BGA TECHNICAL COMMITTEE

TECHNICAL NEWSHEET 9/10/97

TI No. 109/T51 Issue No. 1

TITLE INSPECTION OF DART 15/17M DURAL SPARS

FIG. 1.
INITIAL INSPECTION AREA

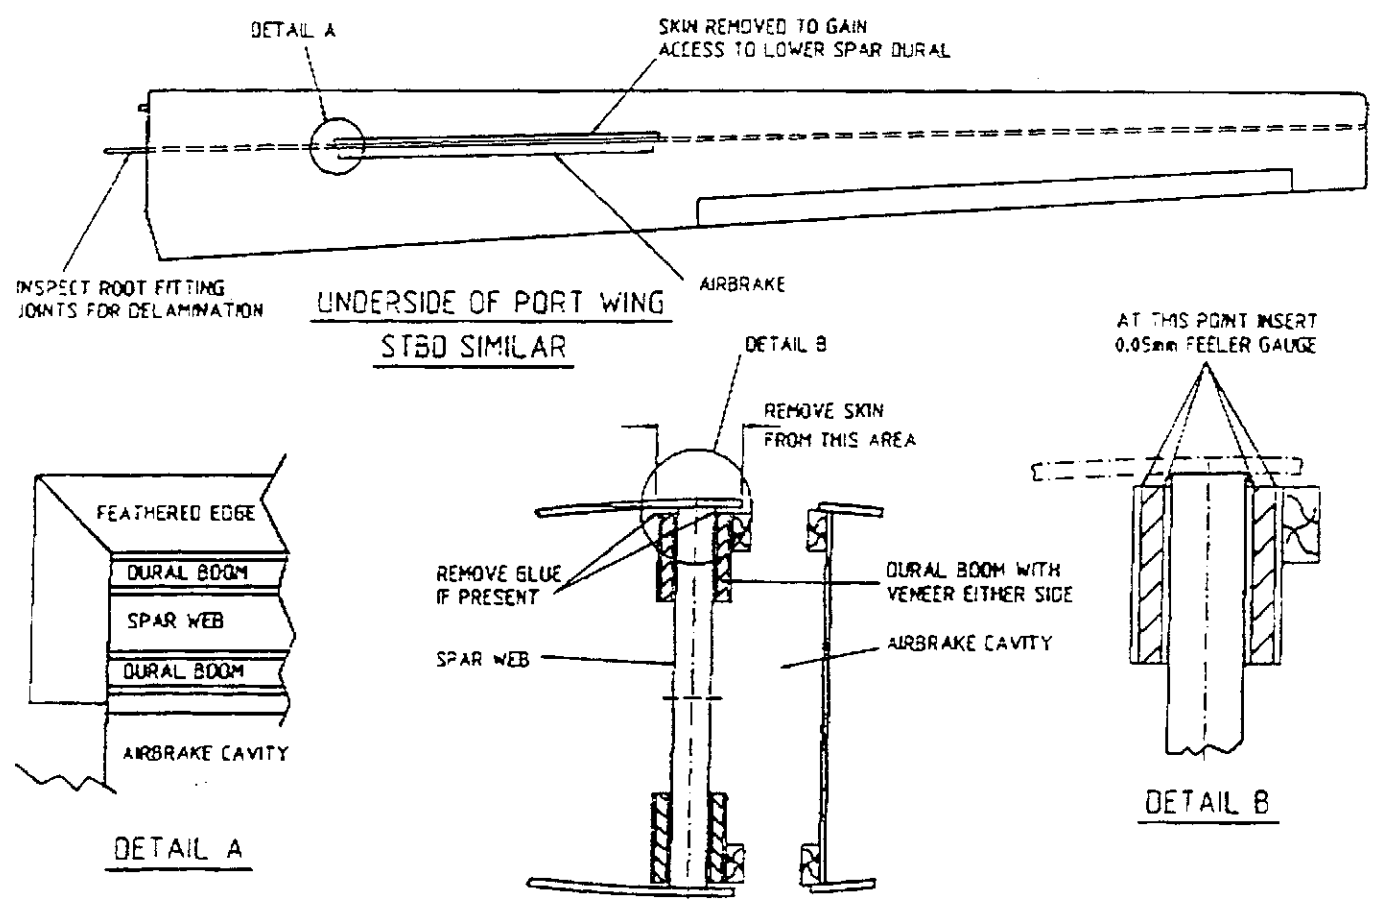
1.
 - i) Carefully remove the ply skin from both wings, over the lower spar for the length of the airbrake box. Refer to Fig. 1.
 - ii) Carefully remove paint to expose root fitting joints.
2. Ensuring dural booms are not damaged, carefully clean away any "Redux" that may have spilt from the joints during manufacture.
3. With the aid of a feeler gauge, .002" (.05mm) check for integrity of all exposed joints for delamination/exfoliation corrosion (white powdering on the metal).
4.
 - i) If delamination/corrosion found then inform SAL before proceeding with repairs.

- ii) If no delamination/corrosion found check for water contamination in other parts of the wing. This can be done by the use of an endoscope. Drill small holes (size to suit instrument) as required in root rib and 'D' box for access.
 - a) If water contamination/exfoliation corrosion is found remove skin over the appropriate area of spar and inspect as paras 3 & 4 i).
 - b) If no contamination/corrosion found refer para 5.
5. Should any doubt exist as to the integrity of the spar, remove the skin locally and inspect as para 3.
6. Upon satisfactory inspection, repair skin, ensuring exposed areas of the metal spar are re-protected. Do not repair using acid hardener based glues. If in doubt contact SAL.

Ensure, following repair, drain holes are not blocked.
